Balboa Park Central Mesa

Precise Plan

Proposed Amendment for
Plaza de Panama, Circulation, and a Parking Structure

April 5, 2012
Sixth Draft

Recovered and Converted Open Public Park Land

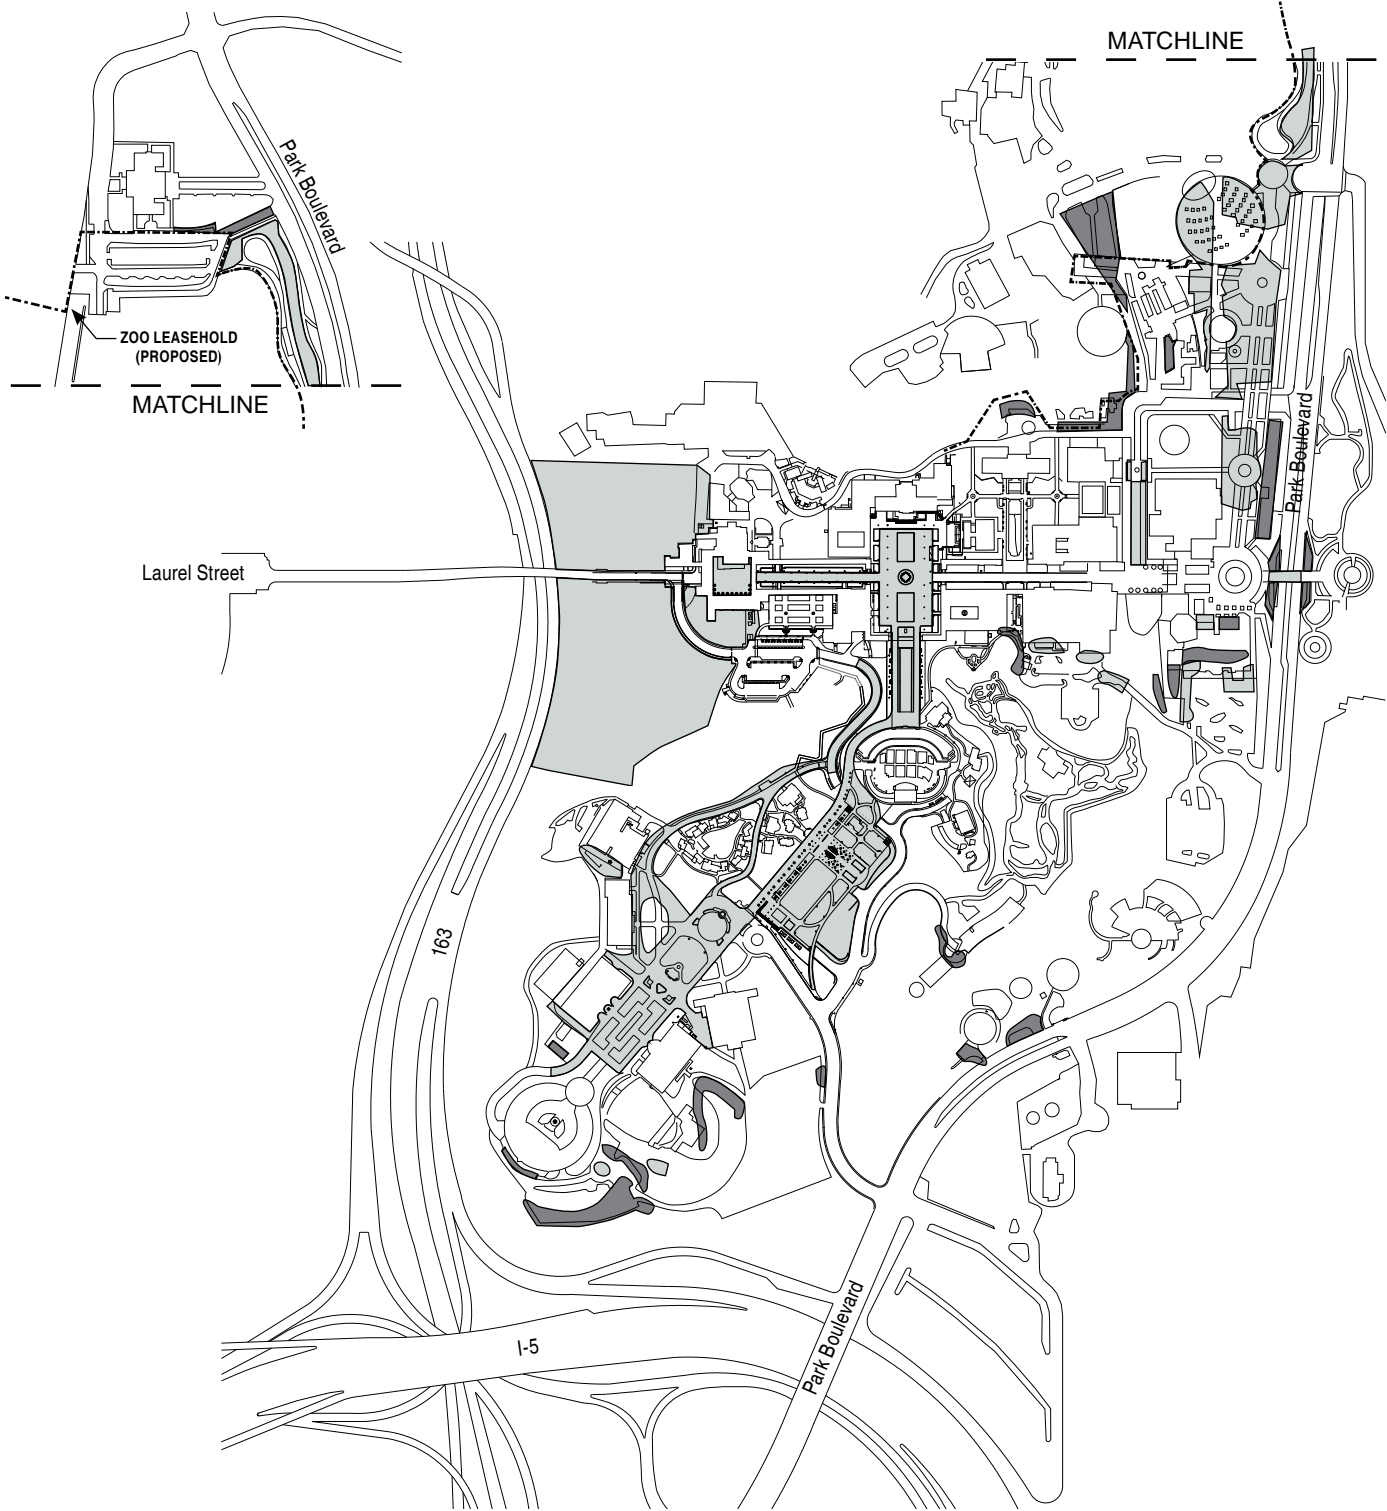
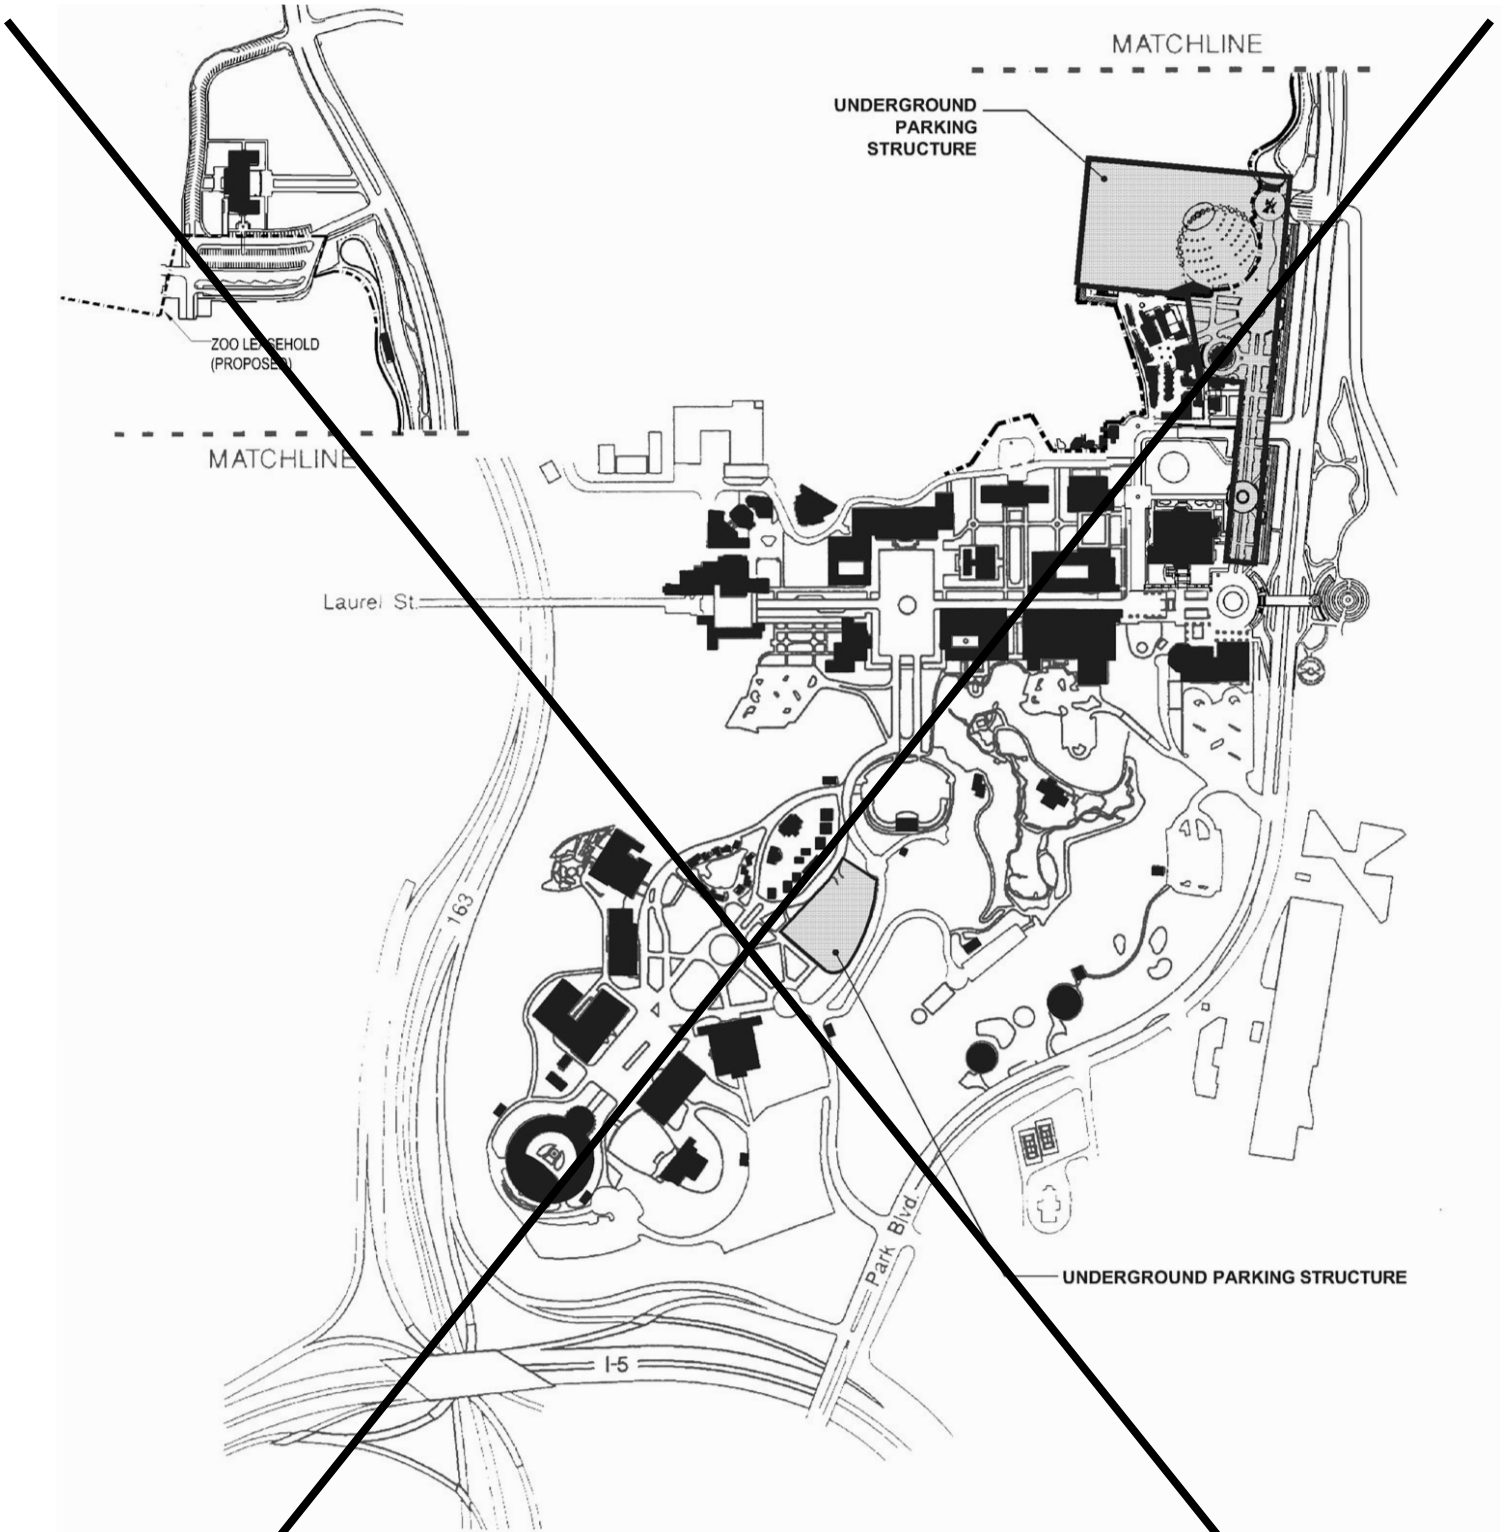
- Open Public Park Land Recovered from other Uses – **32 33** acres
- Open Public Park Land Converted to other Uses – **27 5** acres

Proposed Vehicular Circulation and Parking

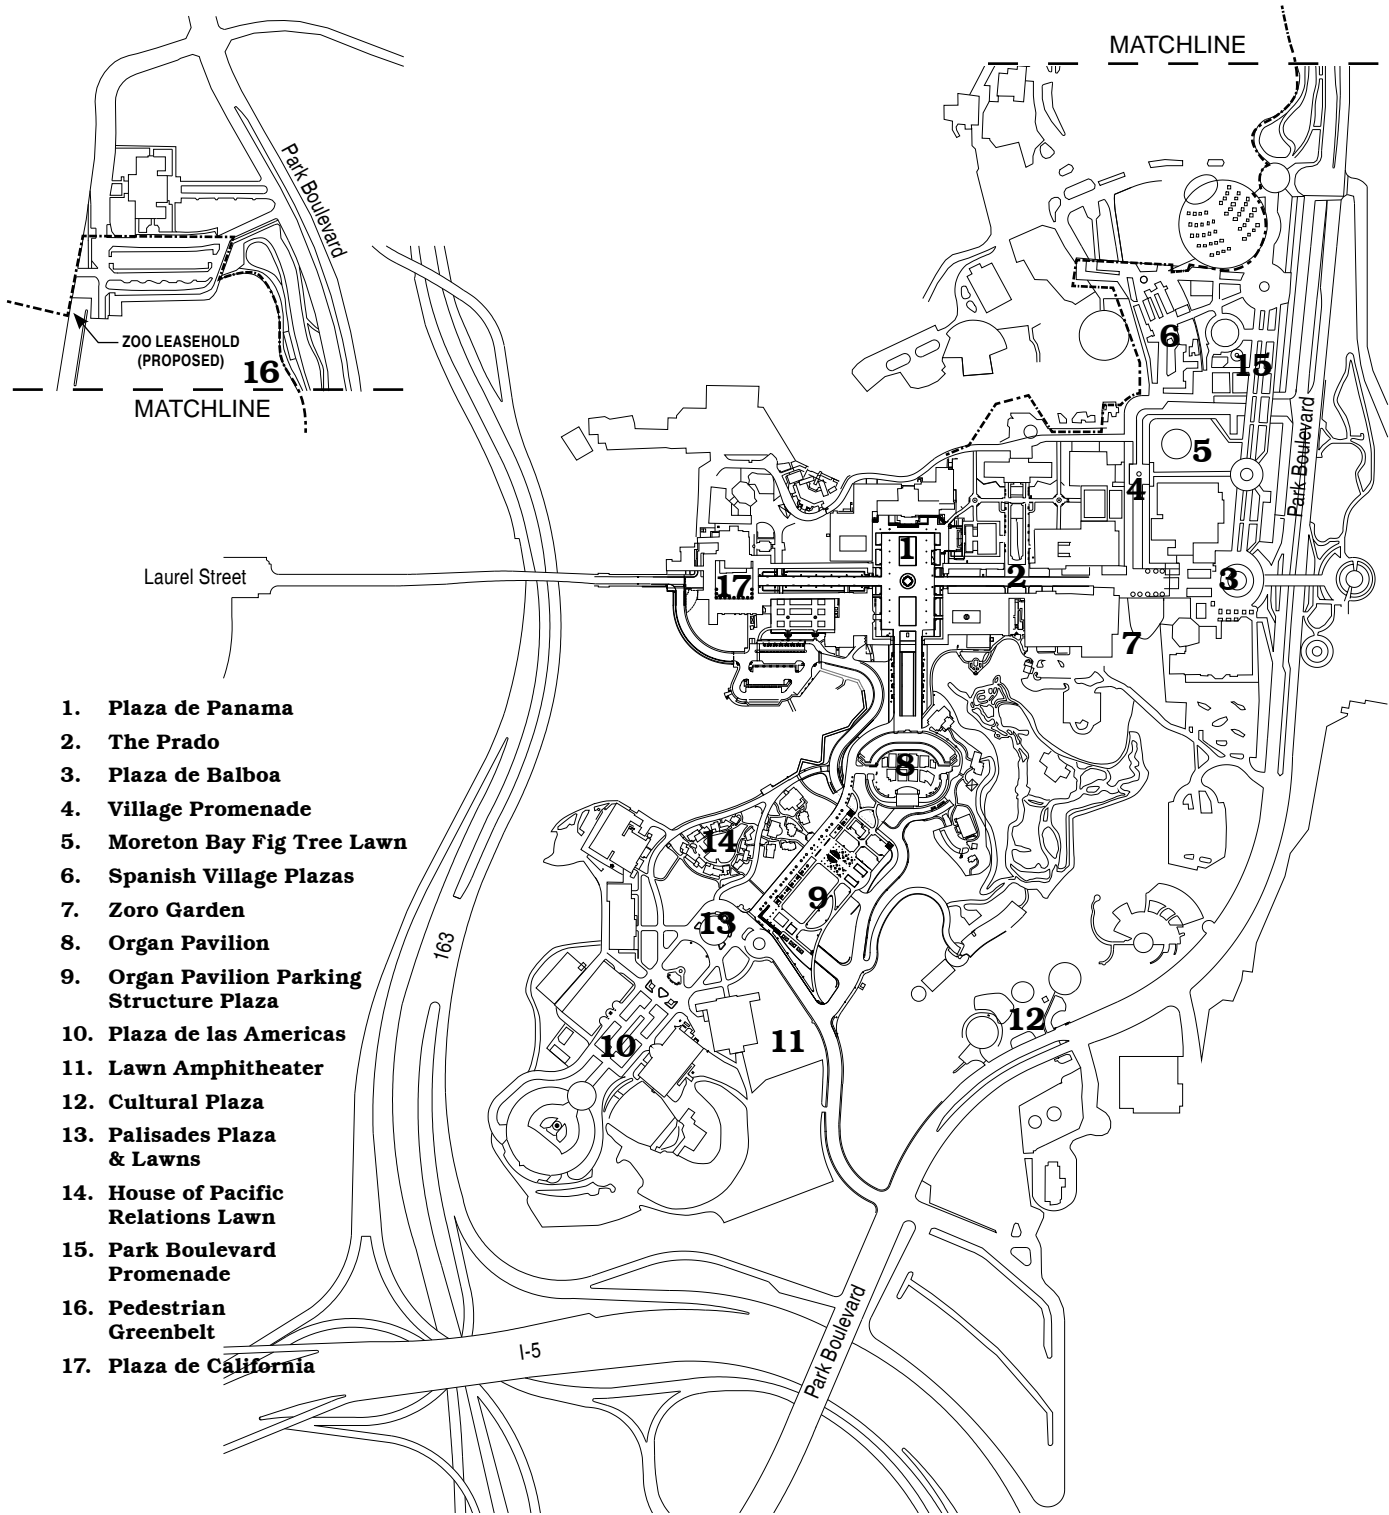
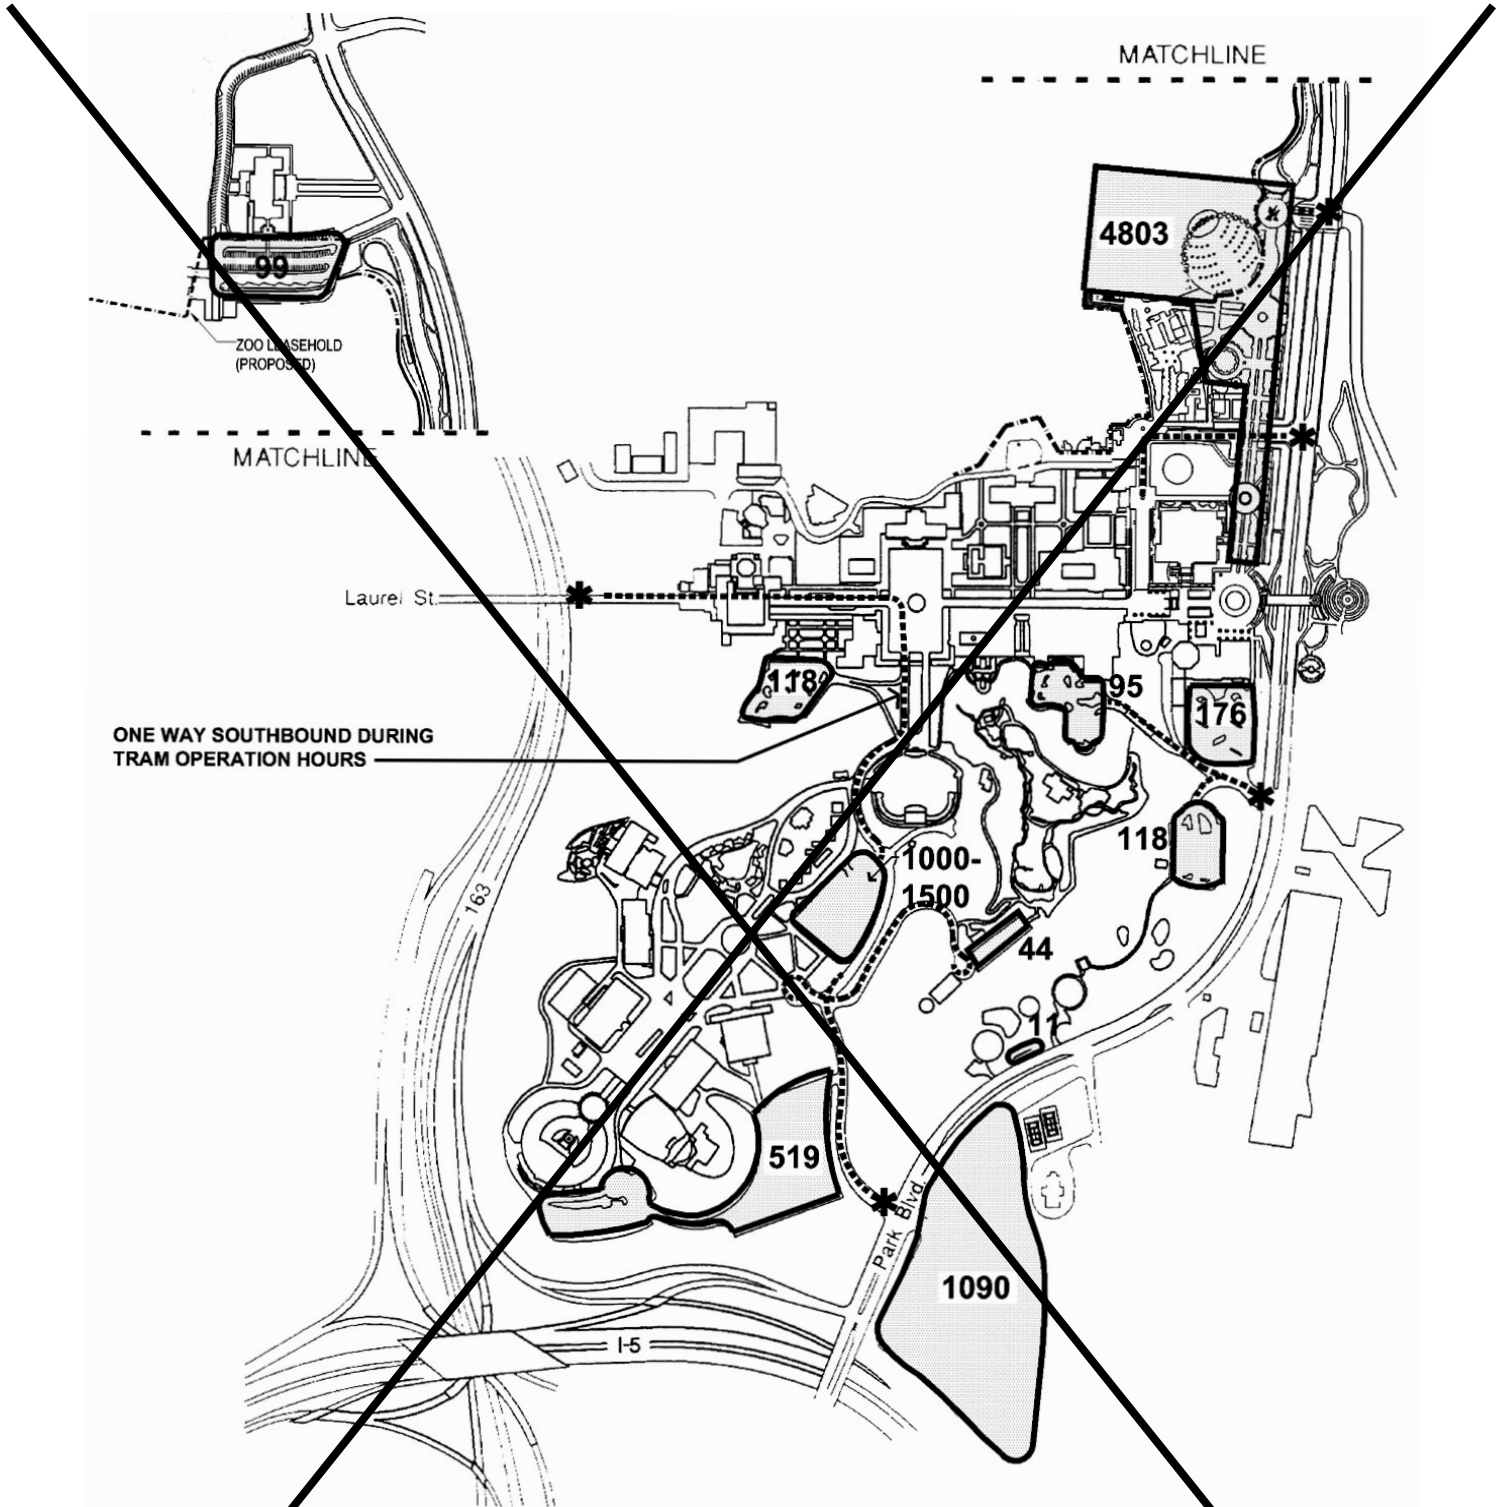
** Organ Pavilion parking garage design to accommodate ~~1,000 – 1,500~~ 750-1,000 parking spaces.

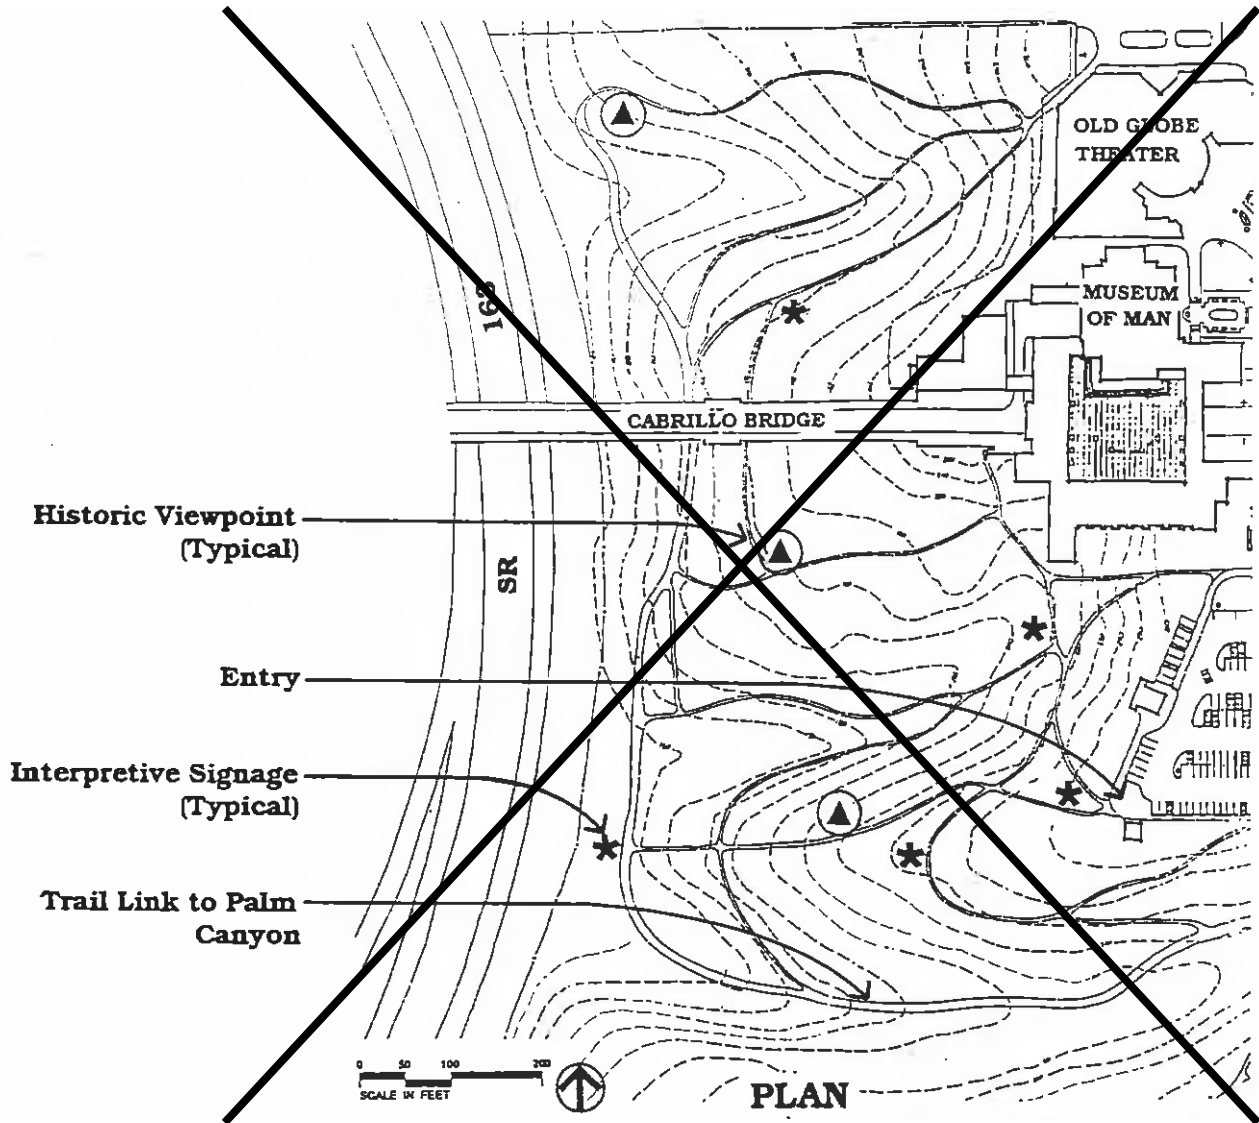
Modify the West Prado in order to ~~provide for automobile turnout lanes while re-establishing~~ re-establish as much of the historical character of this processional space as possible.

- Replace asphalt with decorative concrete paving to ~~match~~ complement existing East Prado paving surface.
- Install a pedestrian drop-off lane on each side of the vehicular circulation lanes ~~as shown on the plan~~.
